Title: **Trees and views of St Paul's from Waterlow Park arboricultural impact assessment – update (v2)**

1.1. The purpose of the report is to conduct an Arboricultural Impact Assessment (AIA) against the new tree maintenance suggested in an additional report to “The view of St. Paul’s from Waterlow Park” by the Trees and Views group on behalf of the Trust Advisory Group (TAG) called: Sight lines of St Paul’s and London from Waterlow Park.

Figure 1 Estimated position of trees

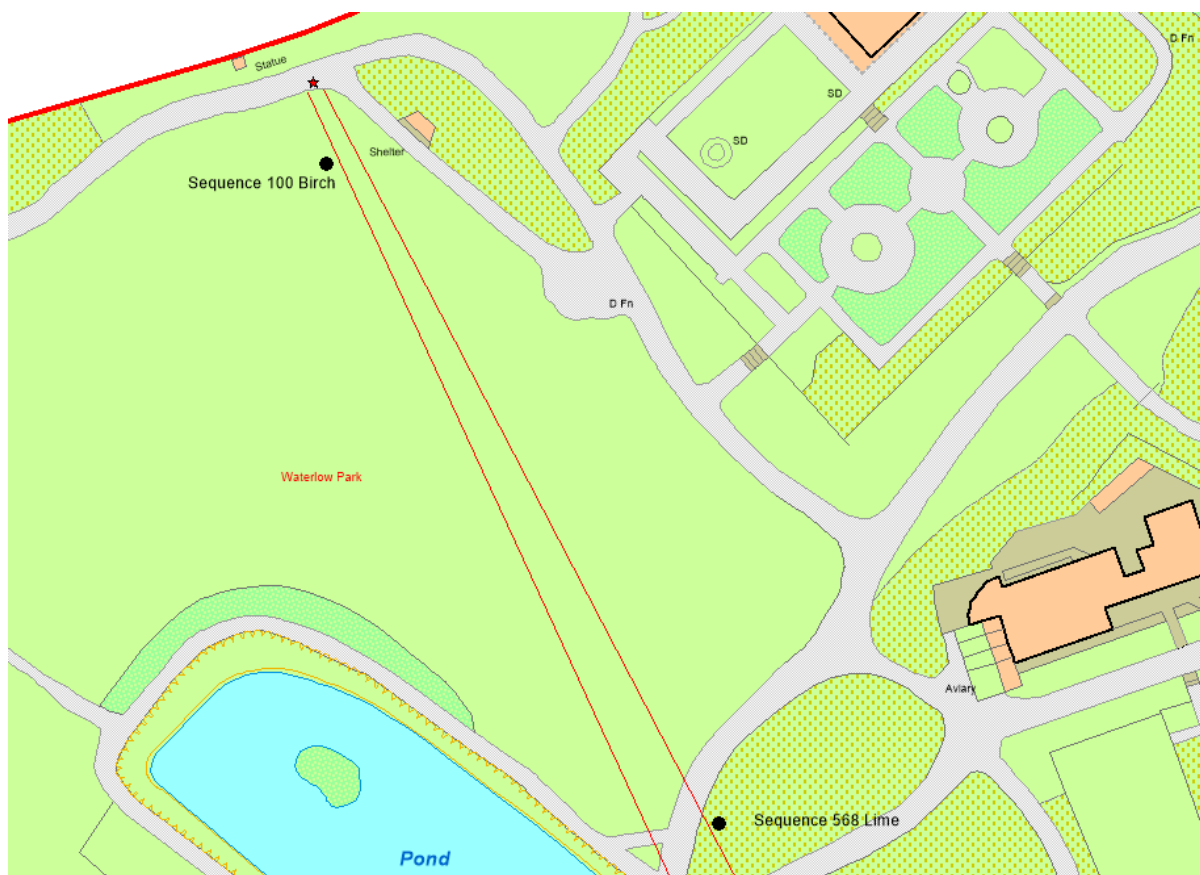
2.3. A new report has been presented by the Trees and Views group with an alternative proposal. They suggest moving the viewing point 11m metres East along the path before the junction of a path leading South down the hill. This places the point behind a different group of trees and moves the view away from the Dawn redwood (*Metasequoia gylpstroboies*).

3.1. The location of the trees implicated in blocking the view can be seen on the map below.

Figure 2 Alternative targeted pruning to clear view of St. Paul's Cathedral. Photograph taken from Sight-lines of St Paul's and London from Waterlow Park. The arrow shows the lime and the triangle the dawn redwood. The orange line is the alternative proposed area of pruning.

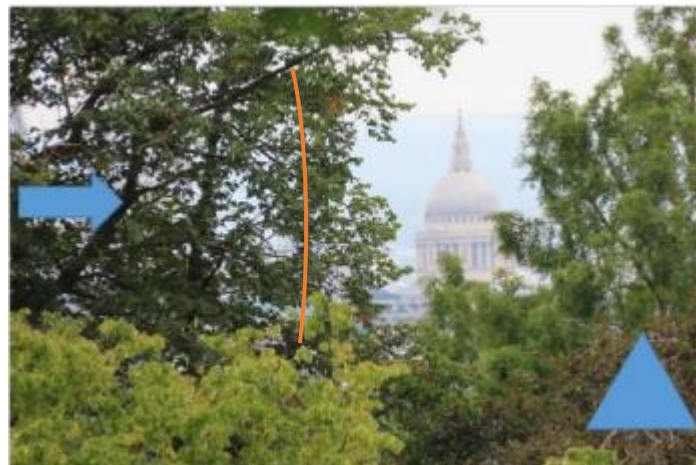
8.1. The report would like the lime to brought down to below the level of the horizon and remove any regrowth on a 3 year cycle. This would require topping the tree, which goes against best practice as set out in the British Standard:3998: Tree work specifications.

8.2. I estimate to carry this out a 50% crown reduction would be needed. This work would leave large wounds, which will take many years to occlude. During this time the tree would be open to attack by pathogens, which will cause decay at this point and reduce structural integrity overtime.

9.1. The lime can be pruned to provide a view to St. Paul's that would avoid topping the tree. Through targeted pruning a view could be created that would blend into the leafy frame the tree canopy provides.

9.3. The view created would be temporary in terms of the lime growing back and the dawn redwood becoming taller and wider. The former can be managed by pruning back as part of our 3 year cycle of programme maintenance, but the latter cannot be stopped without ruining the shape of the tree. I estimate 10-15 years before the dawn redwood covers the view from this point.

9.2. This pruning will be in line with industry best practice and have a negligible effect on the benefits the tree provides.

- 12.3. The alternative proposal for the lime will clear the view to St. Paul's and is unlikely to cause long term harm to the tree or the level of benefits provided. This view can be maintained for approximately 10-15 years, after which the dawn redwood may block it.
